Atlassian Central

Detailed design road safety audit

JMT-PROJ-0001-03 DD RSA ATLASSIAN REV 2

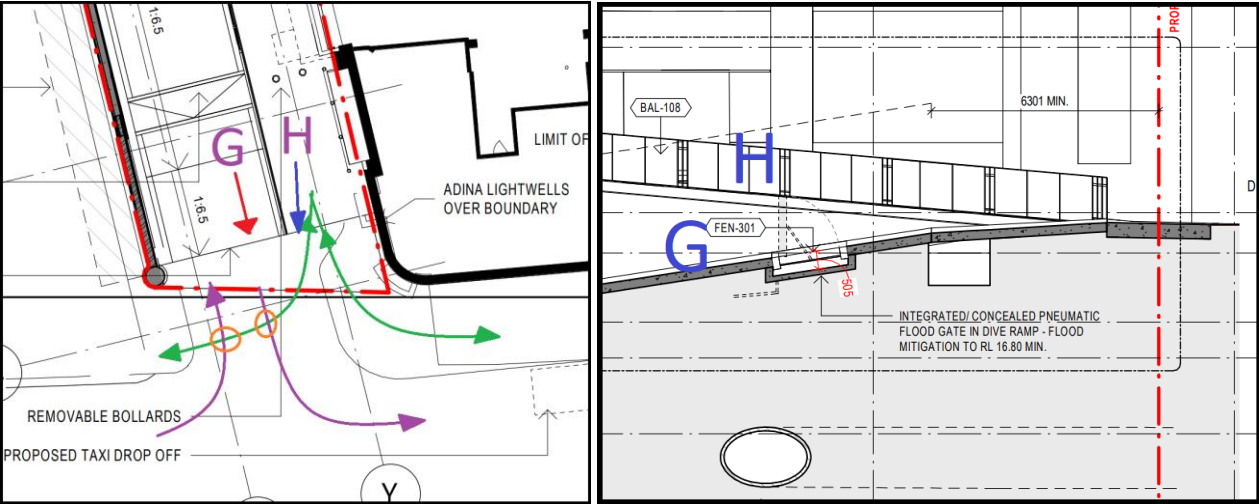
Ref	Location	Previous road safety audit finding – concept design stage	Comment as part of current audit
C3a	Inbound movements into Upper Carriage Lane.	<p>Further to the issues described in item C2, any obstructions to the inbound traffic flows into Upper Carriage Lane, particularly when departing from Lee Street, could have queue spillback risks into Lee Street. Any vehicle that is left standing partially or wholly in Lee Street (and forced to wait due to the obstruction), could be exposed to rear-end impacts by trailing southbound vehicles on Lee Street. Some examples of obstructions include:</p> <ul style="list-style-type: none"> Any parking/ stopping manoeuvres: This includes vehicles stopping and reversing into a kerbside parking position within Upper Carriage Lane. Any stopping required for dropping off or picking up passengers. This includes legal stopping as well as double parking. Low-speed movements by drivers looking for parking spaces or opportunities to stop. It is noted that the Adina Hotel lobby is located on the southern side of Upper Carriage Lane and would generate stopping movements, particularly in the outbound direction. Any u-turning or three-point turning movements which hold up other vehicles. On this note, the audit team has also assumed that there are sufficient opportunities in the site to turn around and head outbound in a forward direction. This includes any inbound movements in error, which then require the driver to turn around. For example, at present under pre-project conditions, there is a boom gate in place a short distance into Upper Carriage Lane. Any drivers that enter this side road in error would be inclined to reverse back out into Lee Street since there is a lack of space to perform a safe u-turn movement. <p>The immediate approach-departure length in Upper Carriage Lane should be kept free of obstructions such as parked cars, stopped buses and vans, deliveries, drop off/pick up transactions etc. Any stopping needs should be confined to further inside this side road well away from the intersection with Lee Street.</p>  <p>Above: There is currently a considerable demand for stopping and kerbside parking in Upper Carriage Lane. Such parked vehicles would pose as obstructions and may lead to queues forming and building up. In particular, any queues in the inbound direction could spill back towards Lee Street.</p>	<p>These issues would still persist with the revised design (shown below). The audit team notes the following:</p> <ul style="list-style-type: none"> Pedestrians accessing the site would need to use the start of the ramp at “A”. As such, there could be many inbound trips generated to pick up or drop pedestrians from point A. By stopping at this location, there would be risks of queue spillback as discussed in item C3a. There is a boom gate at point B. Any queuing as a result of this facility may also spill back towards Lee Street. The driveway channel C is narrow and does not facility u-turns (eg. by vehicles aborting due to the boom gates). Any three-point turns or “five-point turns” could cause delays and queue spillback.  <p>Above: Extract from the detailed design showing the revised layout of the vehicular and pedestrian access to the site.</p>

Ref	Location	Previous road safety audit finding – concept design stage	Comment as part of current audit
C3b	Inbound movements into Upper Carriage Lane.	<p data-bbox="465 209 757 233">Continued from item C3a...</p>  <p data-bbox="465 692 1615 801">Above: Looking eastbound in Upper Carriage Lane under current, pre-project conditions. If features such as the boom gate and kerbside parking are retained in the post-build scenario, these could result in vehicles stopping and generating queues that could spill back into Lee Street. Similarly, any drop off/ pick up transactions at the Adina Hotel could also generate similar stopping behaviour.</p>	<p data-bbox="1653 209 2092 371">The revised layout of the driveway will be significantly different than the existing conditions shown here. However, as discussed in item C3a, there would still be a risk of queue spillback into Lee Street.</p>

Table 3 Road safety audit findings – detailed design stage.

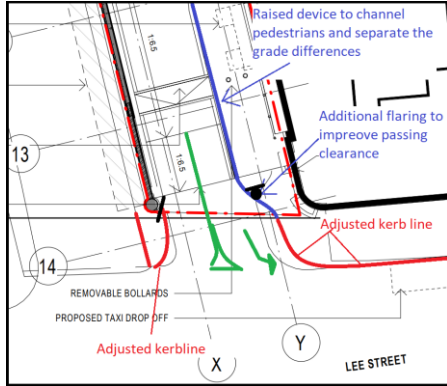
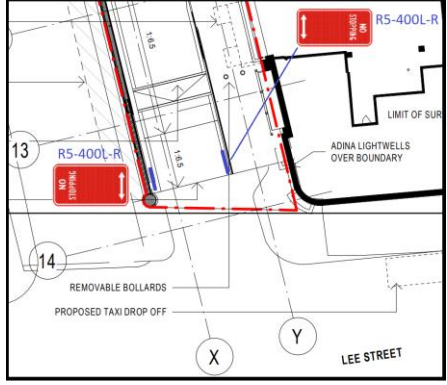
Ref	Location	Road safety audit finding – detailed design stage	Priority
3.1	Interaction between vehicles and pedestrians in Upper Carriage Lane at its opening from Lee Street.	<p>The revised design has a dive structure for road vehicles to access to the Adina Hotel basement and Atlassian, as well as a ramp for pedestrian access to these properties. Northbound vehicles on the ascending ramp and northbound pedestrians on the descending ramp would converge towards each other from different grades/ levels with risks of each user not being able to see the other clearly. This could increase the risk of <i>vehicle-pedestrian</i> collisions. This is especially if the pedestrian walks centrally along their ramp such that the driver's view of them is obstructed by the ramp itself. The same conflict would arise for vehicles at G versus cyclists descending from point H. It should be noted that there are bicycle racks proposed for the development and would be accessible via the pedestrian ramp.</p> <p>There are also multiple <i>vehicle-pedestrian</i> conflicts involving pedestrians crossing to/from the north, and inbound-outbound vehicles.</p>  <p>Left: Outbound vehicles would tend to ascend the ramp from point G and converge towards pedestrians that descend their ramp from point H. These two users would converge on each other with potentially limited visibility of each other. This could increase the risk of vehicle-pedestrian collisions. Other vehicle-pedestrian conflicts are also circled in orange. Right: A long section showing the impact of the different grades/ levels that pedestrians (H) and vehicles (G) would converge towards each other from.</p>	Medium

Ref	Summary of issue	Recommended improvement measure
Table 3, item 3.1	Conflict between vehicles and pedestrians in Upper Carriage Lane at its opening from Lee Street.	See the recommendation for item C2 above.
